ADDRESS: 15002 ASHTON

APPLICATION NO: #23-8399

HISTORIC DISTRICT: ROSEDALE PARK

REPLACE ALUMINUM WINDOWS WITH VINYL WINDOWS

15002 Ashton. Designation photo, taken in 2008

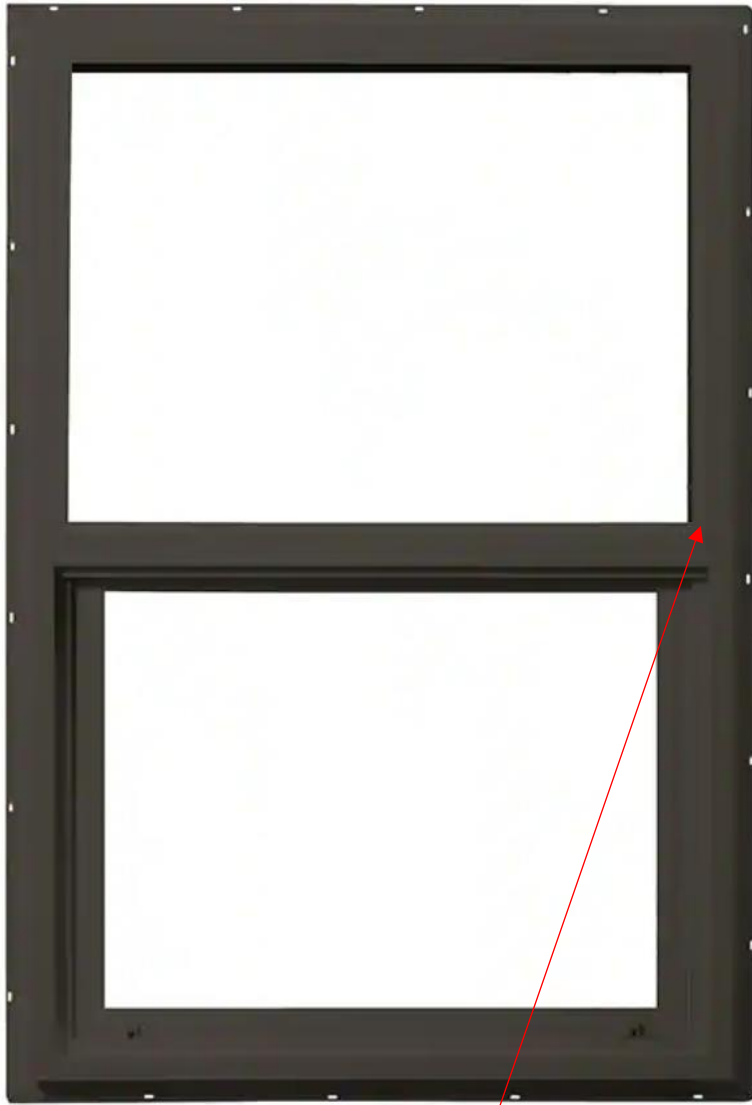
2009 Google Streetview image. Note the presence of steel casement windows at the casement windows at the rear wing's first story and the side elevation's first story. Also a rear deck and gate is not present in 2009 and the garage doors are different from the current single overhead door.
